**ADDENDUM
NO. 4**

April 21, 2022

**RIVER VALLEY HIGH, MIDDLE, & ELEMENTARY SCHOOLS
ADDITIONS & RENOVATIONS
15480 Three Oaks Road
Three Oaks, MI, 49128**

This Addendum consists of Pages ADD 4-1, RFI Log, and Cordogan Clark Addendum No. 4, dated April 20, 2022, consisting of 5 pages, and Revised Drawings: C8, A6.6, A8.4, A9.2, M1.1D, M2.1A, M2.1D, M2.2B, M4.0, P2.1D, E2.1A, E2.1B, E2.1C, E2.2A, E2.2B, and E2.2C.

1 ELECTRICAL POWER PLAN - AREA B
1/8" = 1'-0"

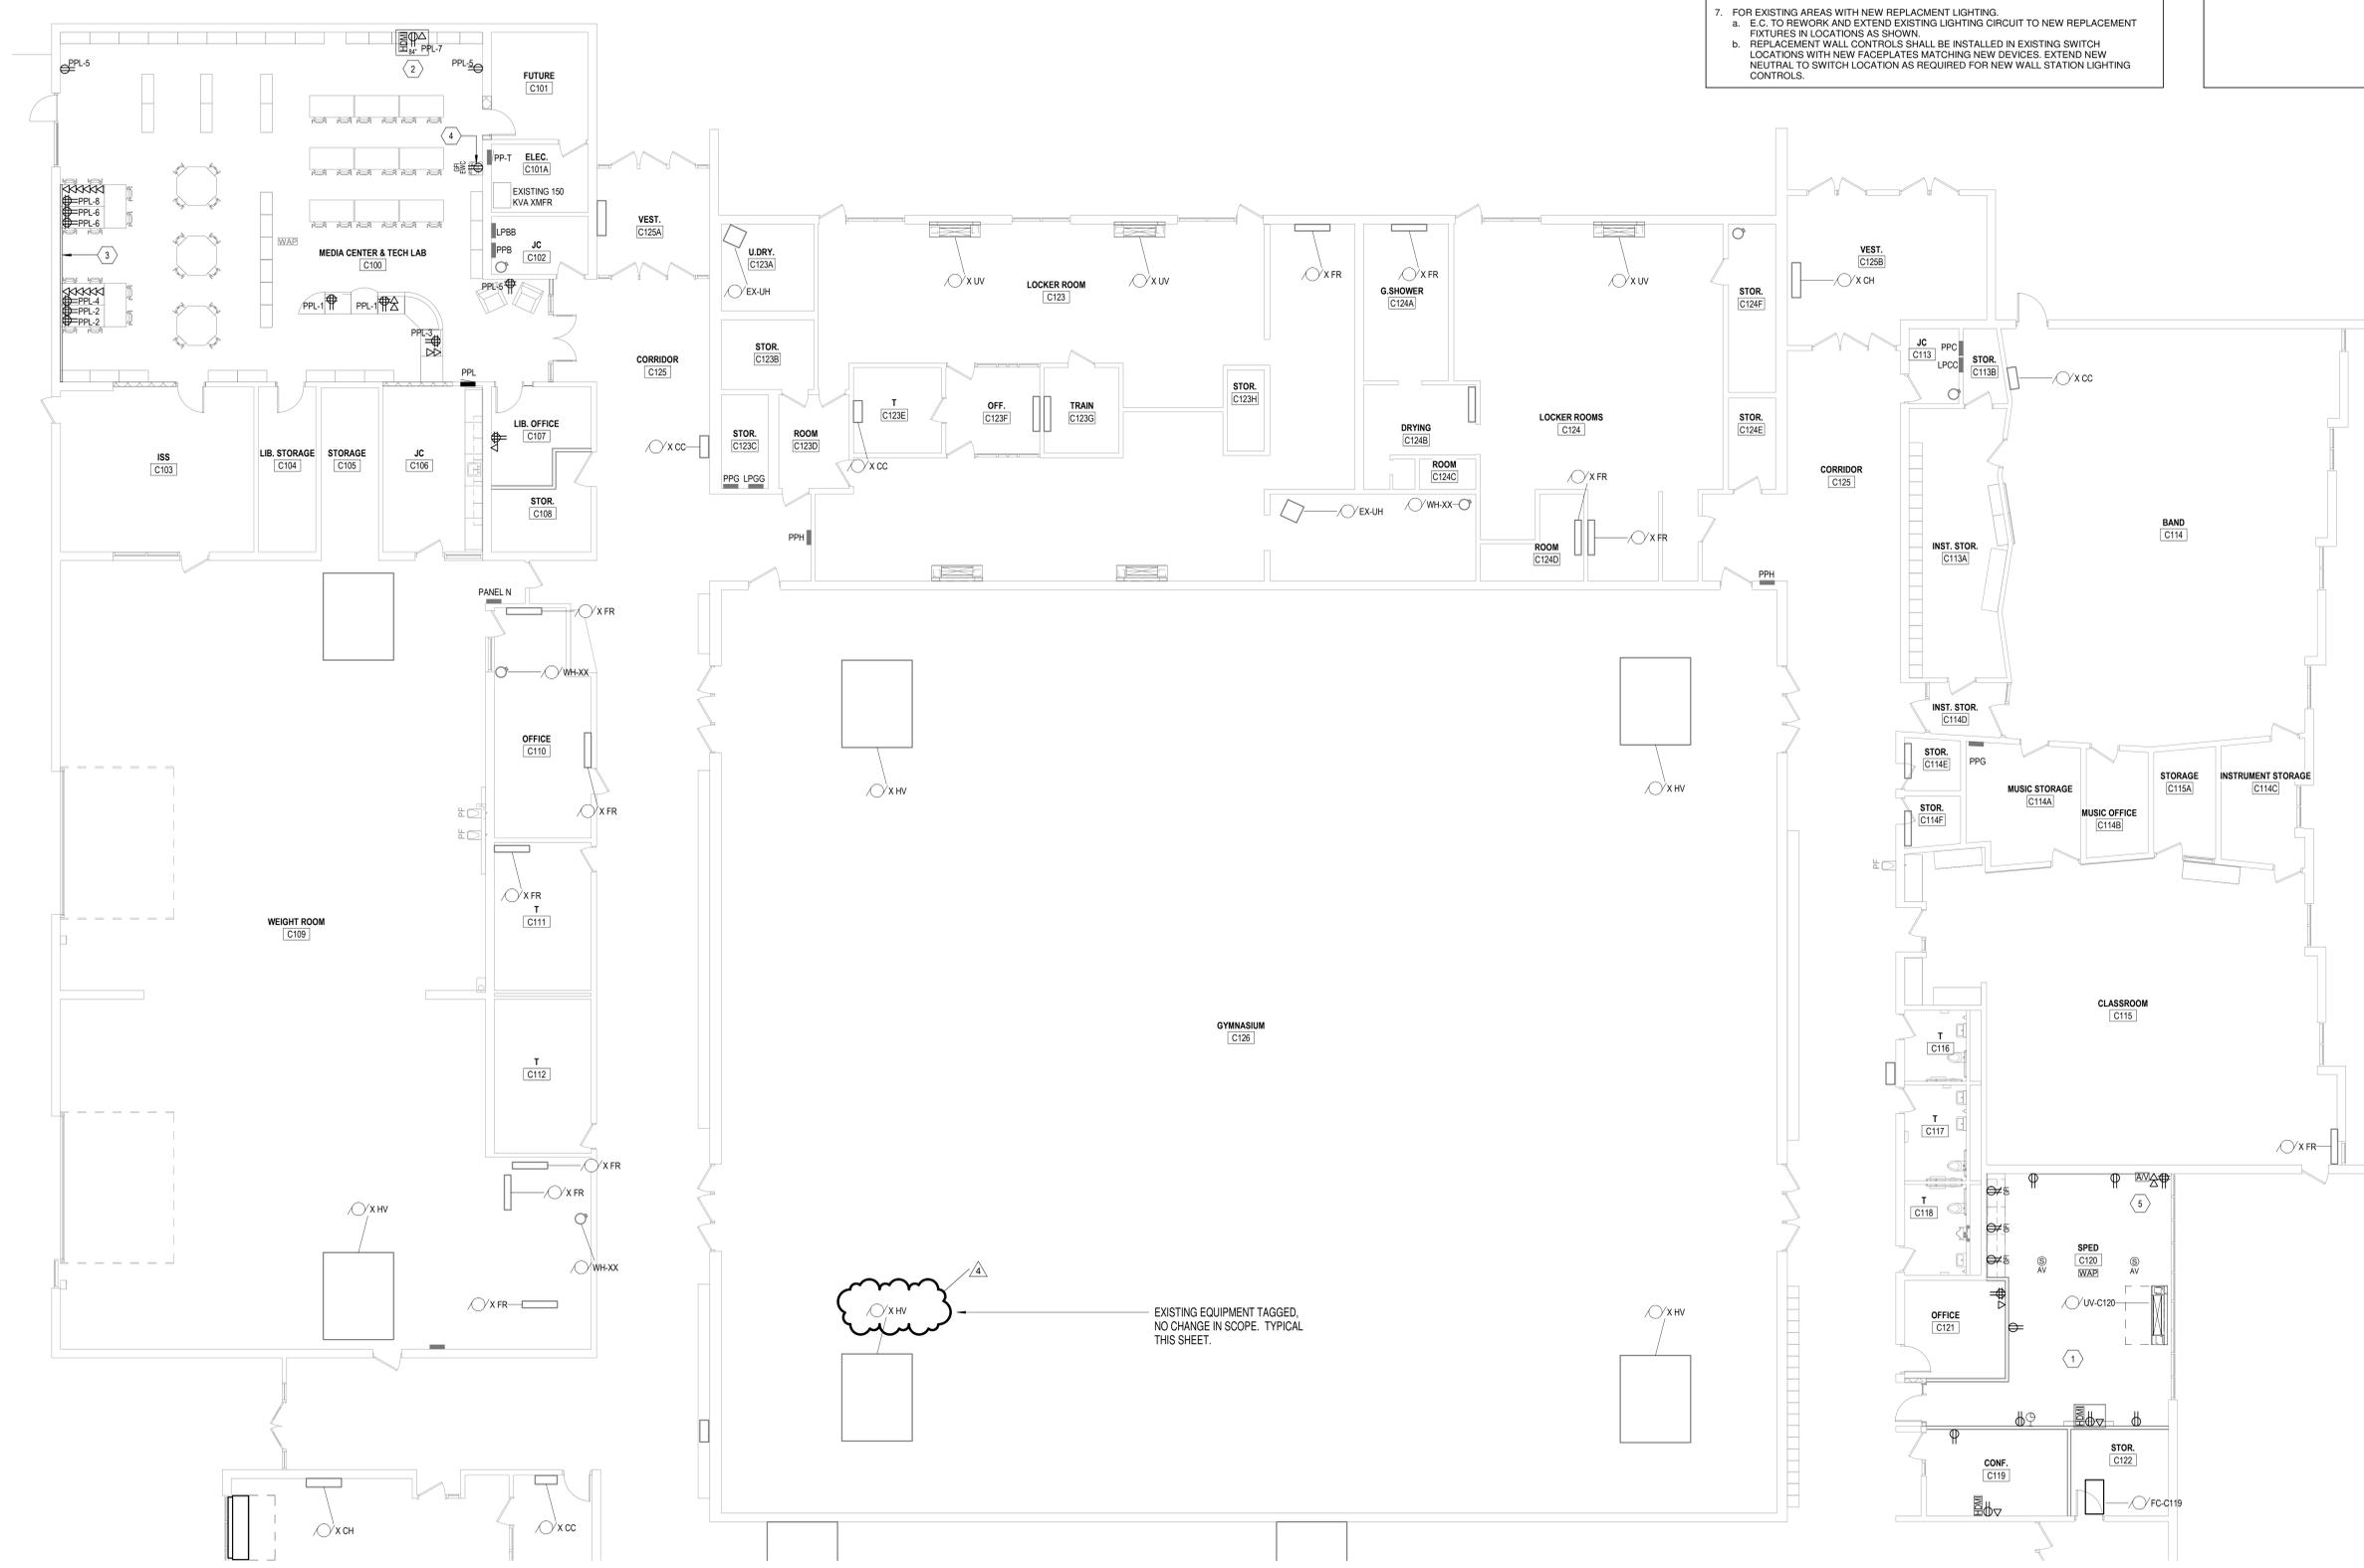
Sheet E2.1A, E2.1B, E2.1C

- ADD Mechanical Equipment tags. Schedules for new PP-E and PP-F are deleted in favor of existing tubs being reworked and partially refed per E4.2.

1 ROOF POWER PLAN - AREA A
 1/8" = 1'-0"

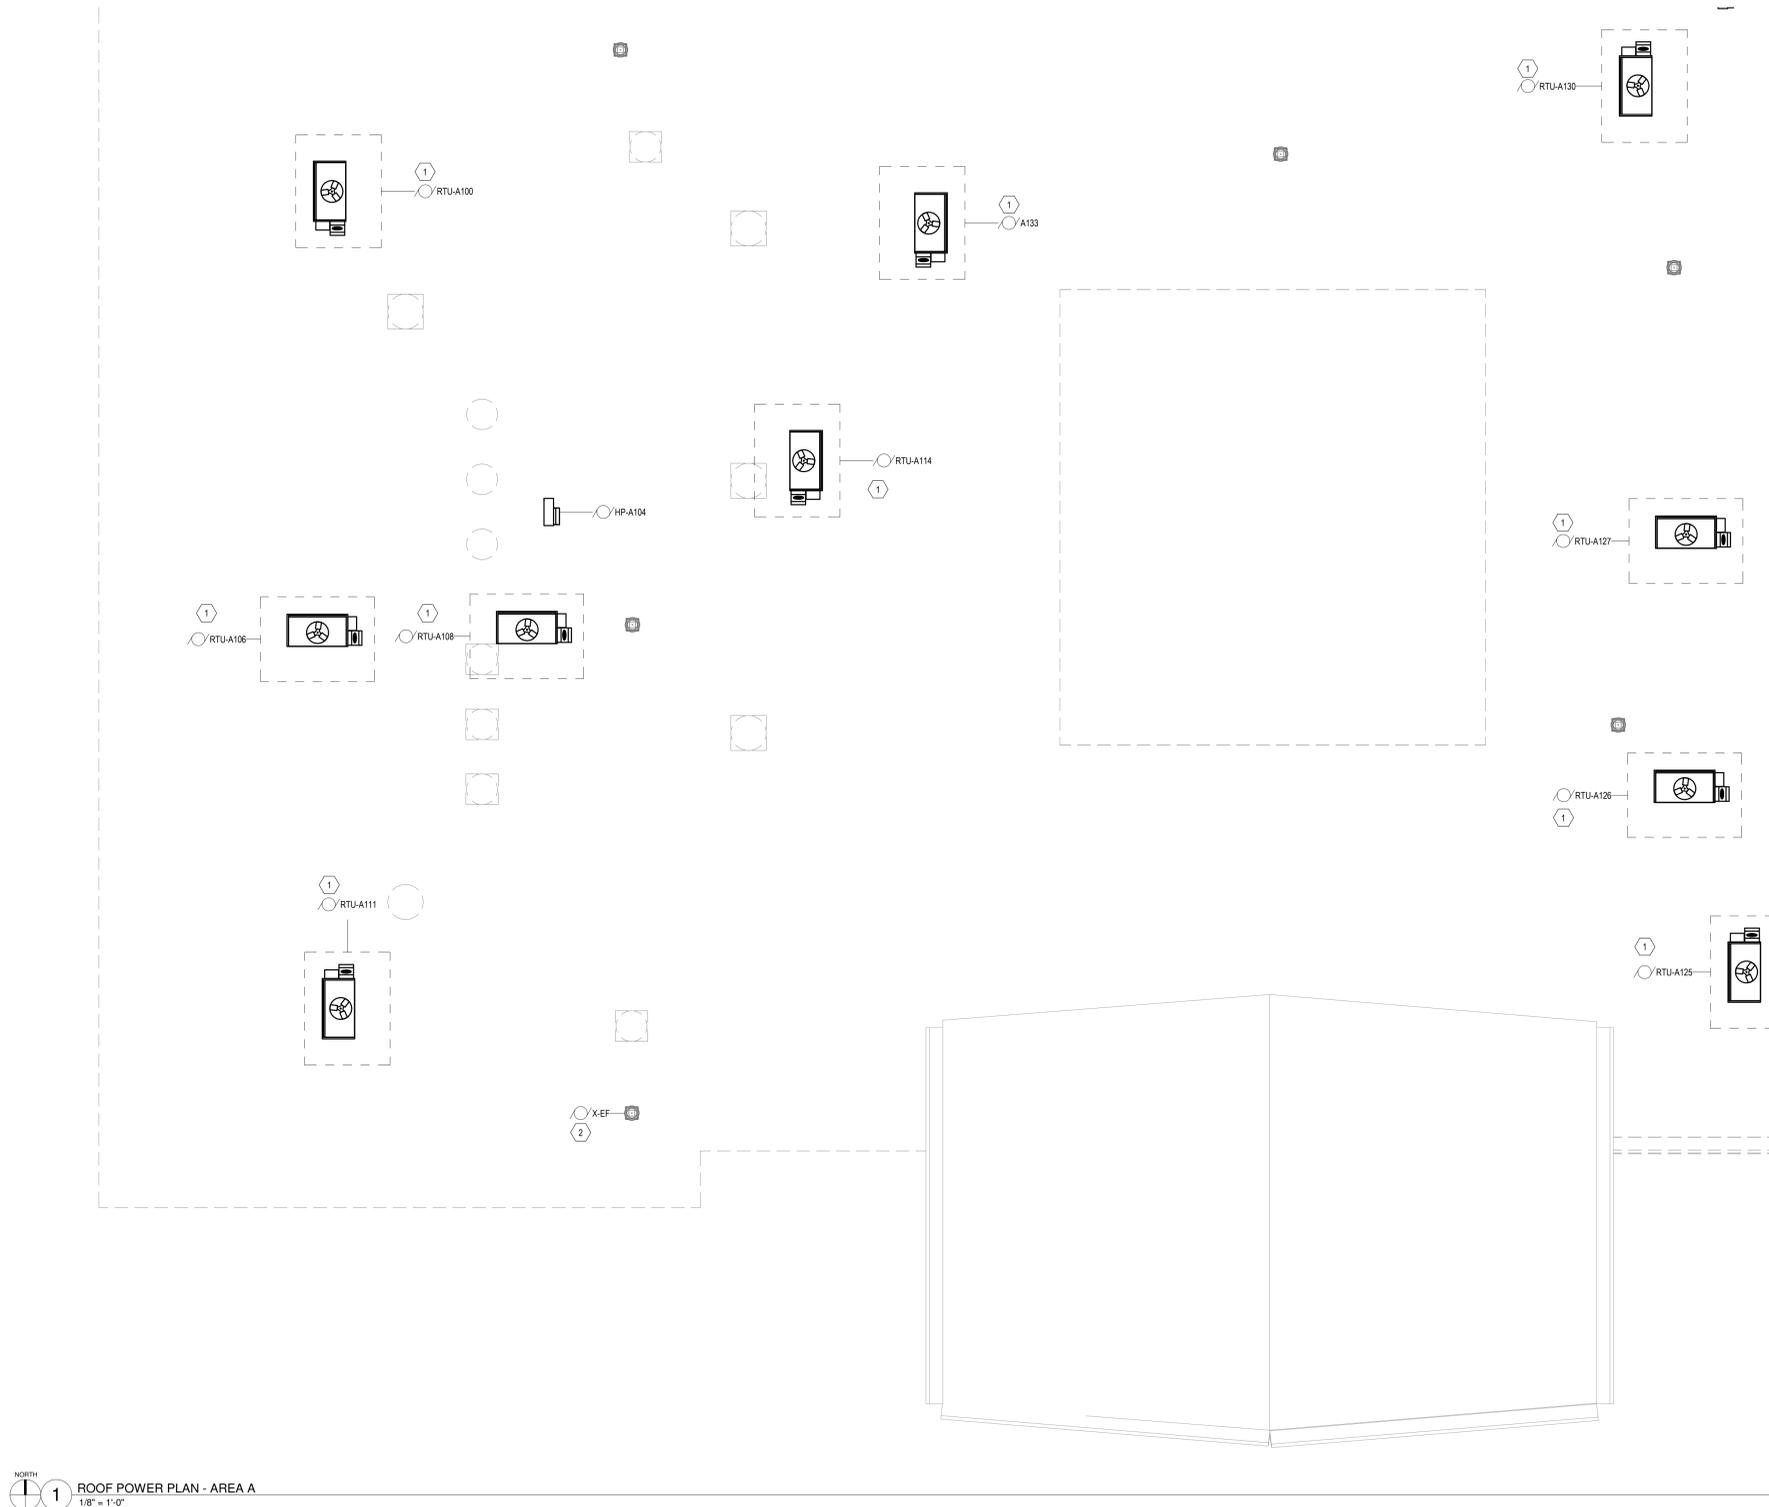
Sheet E2.2A, E2.2B, E2.2C

- ADD New feeders and branch circuit wiring to new mechanical equipment to be ganged as much as possible with new feeders indicated on E2.2. Mechanical equipment in Area D can be fed concealed above new ceilings.
